37 Quincy Street
Cherry Chase

35/13-09 S
2009 HAWP

From: Fothergill, Anne
Sent: Monday, October 10, 2011 1:58 PM
Subject: Oct. 12 staff item

37 Quincy is a non-contributing resource in Chevy Chase Village. The HPC approved a 2nd story expansion of this house and the applicants are proposing a minor change to a side elevation of the approved plans. They propose to not install one window in the new second floor that was shown on the left (west) side elevation. Approved and revised plans are attached and an aerial photo.

PROPOSED WEST ELEVATION
SCALE: 3/16" = 1'-0"

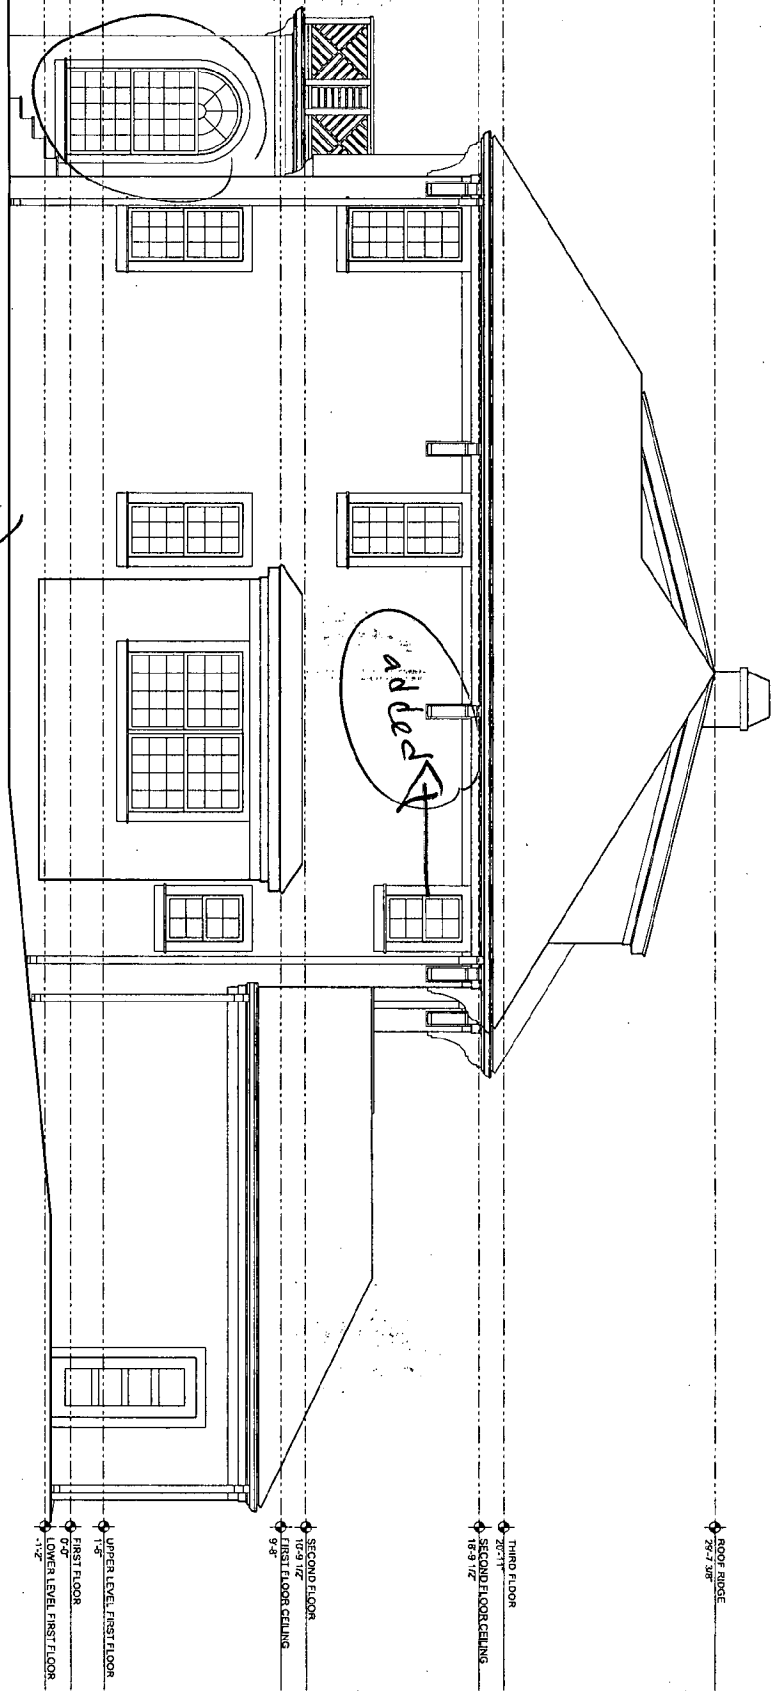
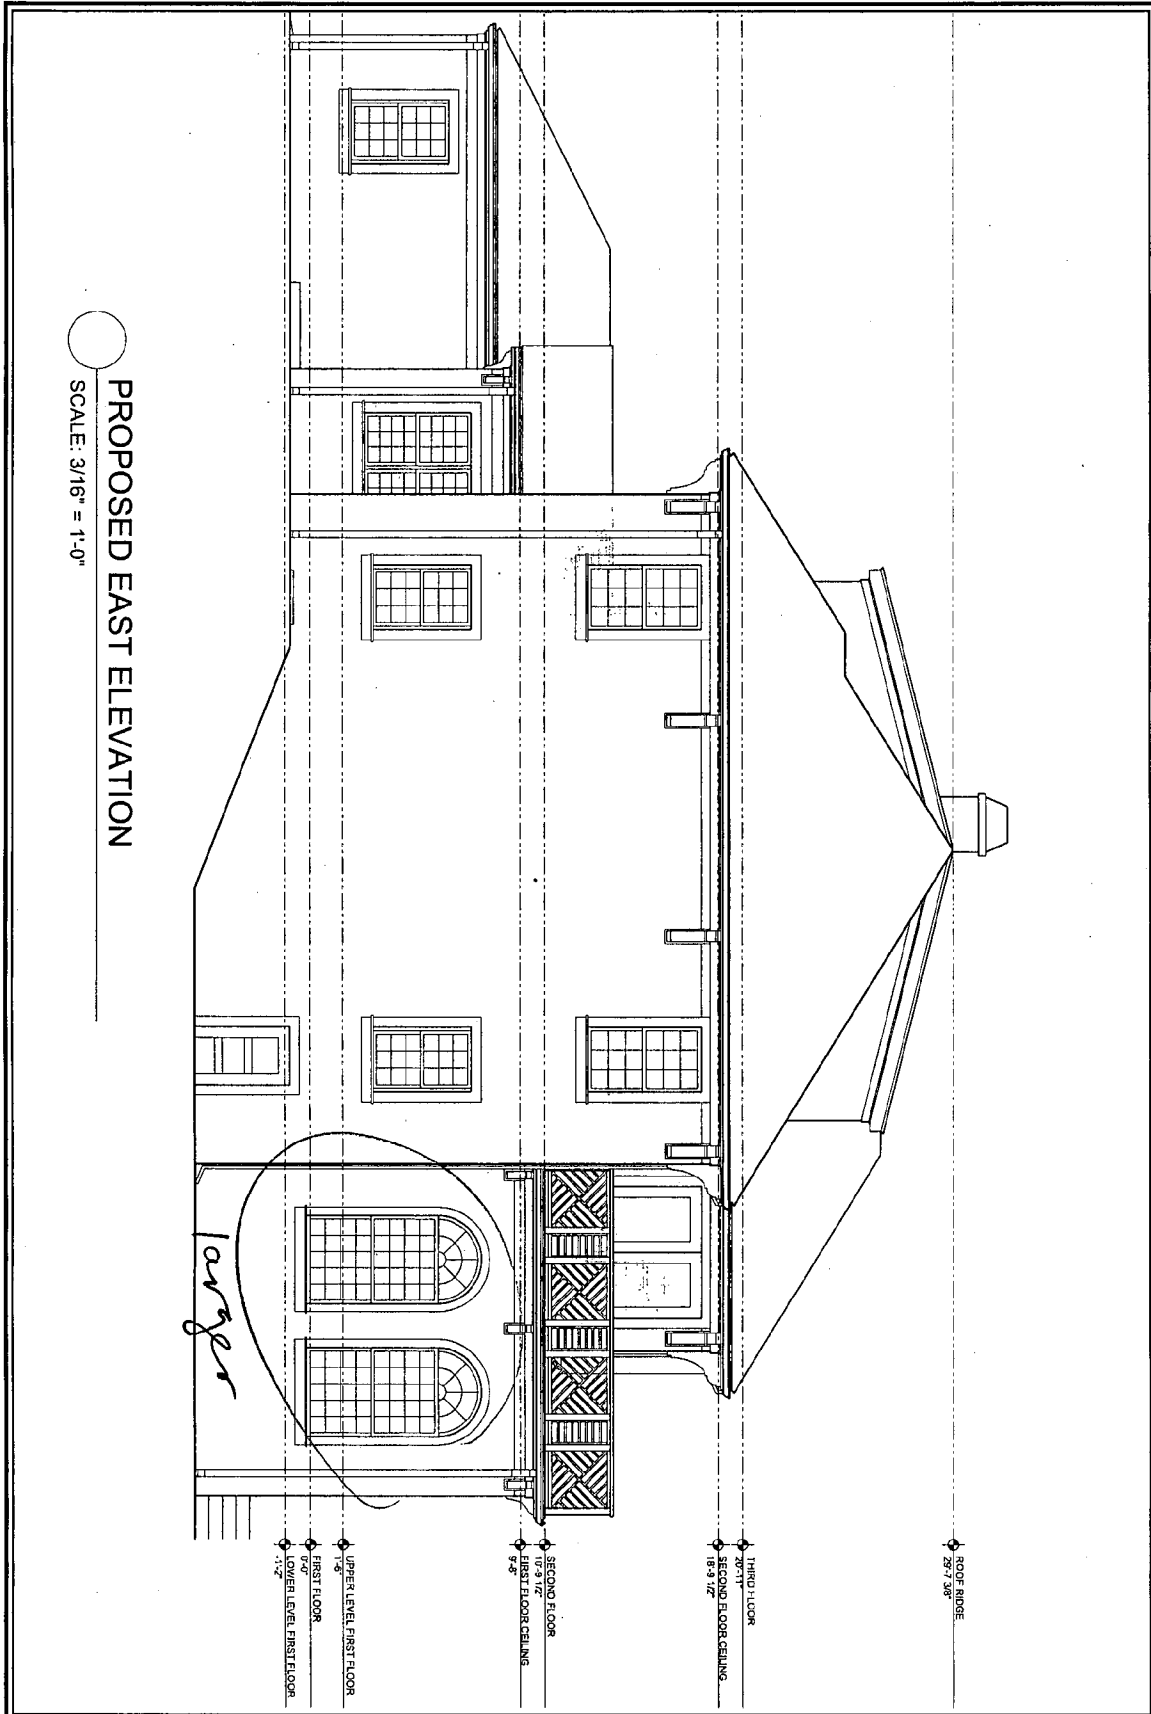
- 1) please check the east and west elevations to make sure the dormers match up on both. It appears that the north side dormer has a different pitch in the two elevations. The HPC has a number of architects who will definitely scrutinize the roof plan so I would recommend double checking the plans.
- 2) Can you explain what is going on with the roof as seen in the west and east elevations? Both show a strange angle that I am not sure I understand.
- 3) the Overhead door Shaker style. Please send web link so I can print it out

HEIGHT COMPARISON
SCALE: 1/4" = 1'-0"

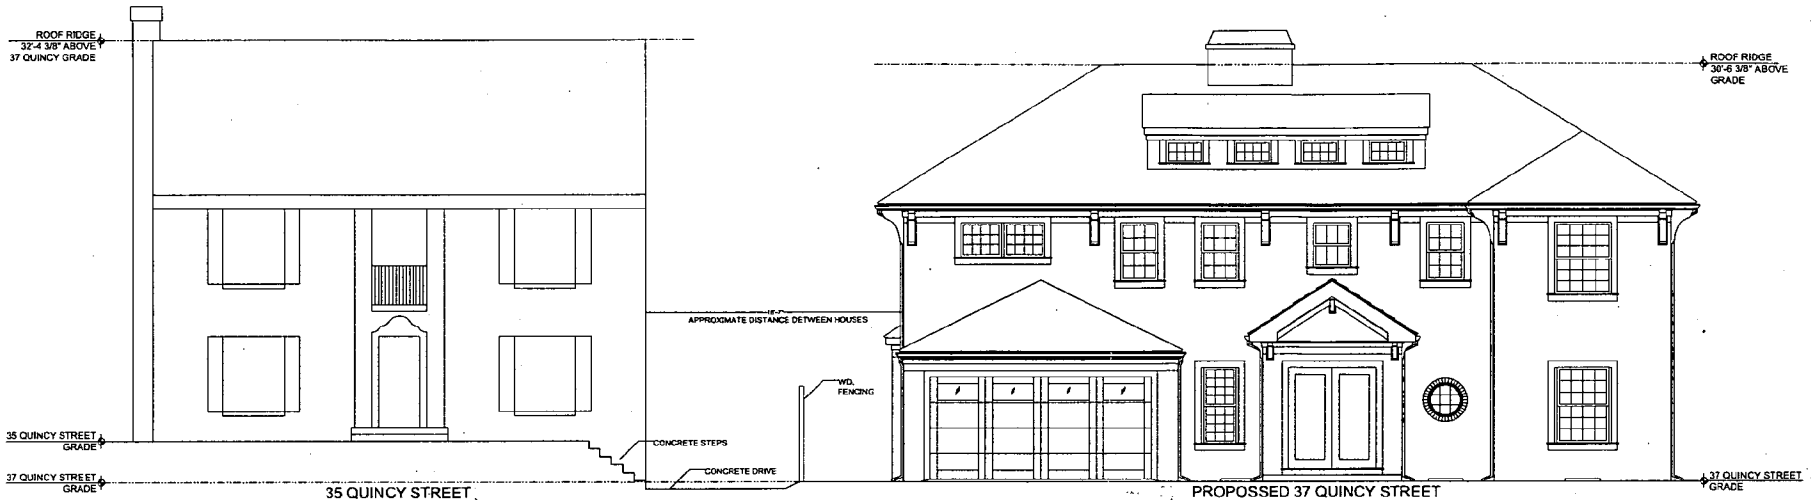
One point I want to make, that I didn't have a chance to ask you, I'd like to get from you a more accurate elevation study. The drawing that we got in the packet that was sent in tonight shows a grade change between the adjacent house and this lot, but there aren't any elevation dimensions or dimension strings that show the actual heights.

Is this based on someone's actual survey, and is the drawing of the adjacent house an accurate, has it been measured and drawn accurately?

in the next preliminary, which I would recommend, an accurate drawing of the adjacent elevation, property, and accurate elevation points in terms of your proposed height to the ridge and chimney and so on, and relative to the adjacent property. And it would be easier to evaluate the proposal with that information.
